RESPONSE TO REQUEST FOR ADDITIONAL INFORMATION

APR1400 Design Certification

Docket No. 52-046

RAI No.: 527-8686
SRP Section: 03.11 - Environmental Qualification of Mechanical and Electrical Equipment
Application Section: 3.11
Date of RAI Issue : 10/21/2016

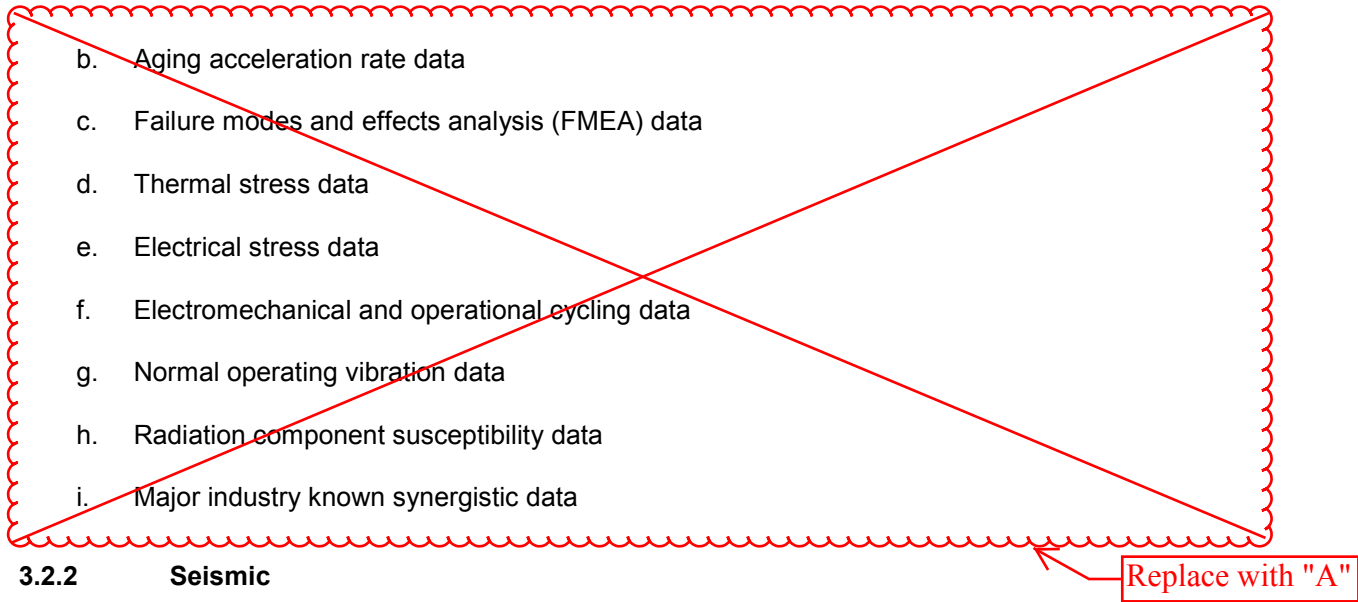
Please discuss how natural aging supplemented by analysis addresses the end-of-installed-life condition and demonstrates that the equipment remains functional during and following design basis events, in accordance with 10 CFR 50.49(e)(5)

A discussion on natural aging will be added to Section in 3.2.1.2 of APR1400-E-NR-14001-P/NP to more clearly align it with the requirements of 10 CFR 50.49 as shown in Attachment.

Replace with "A"
